Z-97  
(2016)

**SITE PLAN FOR**  
**Single-Family Homes (RA-5)**  
#1189 Vester Drive  
Landlot 965 of the 16th District  
Marietta, Cobb County, Georgia

**PETITION NO:** Z-97

**ZONING COMMENTS:**

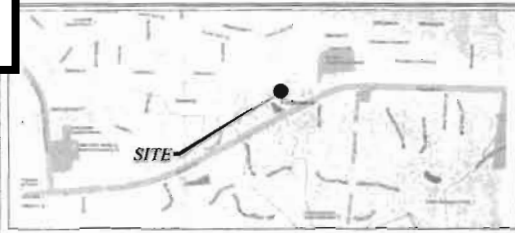
As the proposed development abuts a cemetery to the west, a cemetery buffer may be required along this side that is not shown on the current site plan. Also, a ten foot landscape buffer will be required along the northern edge where the development abuts a more restrictively zoned property.

- A. Prepare a site plan identifying the full boundaries with a metes and bounds description.
- B. Provide a fifty (50) foot undisturbed natural buffer from the common property line; or a fifty (50) foot undisturbed natural buffer around the perimeter of the outermost burials of the cemetery; whichever provides the greatest protection for the cemetery.

- C. Lots adjacent to the fifty (50) foot undisturbed natural buffer shall have setbacks in addition to the buffer.
- D. The fifty (50) foot undisturbed natural buffer shall be recorded as a conservation easement with the Cemetery Preservation Commission having third party right of enforcement.

- E. Provide and install a permanent six (6) foot chain link fence on the outer perimeter of the fifty foot undisturbed buffer. Fence must be 9 gauge with top and bottom rails and fence posts must be set in concrete. Fence may be upgraded to black vinyl coated chain link and/or wrought iron.

- F. Provide and install an orange protective fence on the outer perimeter of the fifty (50) foot undisturbed natural buffer before beginning construction. The protective fence to be maintained in good repair throughout the development phase of the project. At completion of the project, the orange protective fence shall be removed from the premises.

- G. Permanent signs stating CEMETERY PRESERVATION BUFFER – DO NOT DISTURB shall be erected at fifty (50) foot intervals along the outer perimeter of the fifty (50) foot undisturbed natural cemetery preservation buffer.

Additional Comments: Relocation of existing sewer may be necessary, depending on final lot layout.

- Provide comprehensive hydrology/stormwater controls to include development of out parcels.
- Submit all proposed site improvements to Plan Review.
- Any **spring activity** uncovered must be addressed by a qualified geotechnical engineer (PE).
- Structural fill must be placed under the direction of a qualified registered Georgia geotechnical engineer (PE).
- Existing facility.
- Project must comply with the Water Quality requirements of the CWA-NPDES-NPS Permit and County Water Quality Ordinance.
- Water Quality/Quantity contributions of the existing lake/pond on site must be continued as baseline conditions into proposed project.
- Calculate and provide % impervious of project site.
- Revisit design; reduce pavement area to reduce runoff and pollution.

- No Stormwater controls shown \_\_\_\_\_
- Copy of survey is not current – Additional comments may be forthcoming when current site conditions are exposed.
- No site improvements showing on exhibit.

1. This site is located at the northwest intersection of Roswell Road and Vester Drive. Approximately one quarter of the site is currently occupied by a 0.5 acre lake that is located in the center of the parcel. The storage effect of this lake provides a stormwater mitigating benefit for downstream property owners that must be maintained or recreated within this redevelopment.
2. The proposed layout will also need to accommodate an adequate drainage system to convey the existing upstream runoff through the site. This will require a 20-foot drainage easement along the rear of Lot 4 and between Lots 3 & 4.

Recommend curb and gutter along both sides and sidewalk along one side of proposed development roadway.

Recommend curb, gutter, and sidewalk along the Roswell Road frontage.

Recommend a no access easement along the lots that border the Roswell Road frontage.

Recommend entrance be located a minimum of 50 feet from the intersection of Vester Drive and Roswell Road.

1. Maximum of three (3) units per acre;
2. Site plan to be approved by the District Commissioner;
3. Code-required ten foot landscape buffer adjacent to northern neighbors to be reviewed and approved by County Arborist;
4. Cemetery Preservation Commission comments and recommendations;
5. Water and Sewer Division comments and recommendations;
6. Stormwater Management Division comments and recommendations; and
7. Department of Transportation comments and recommendations.
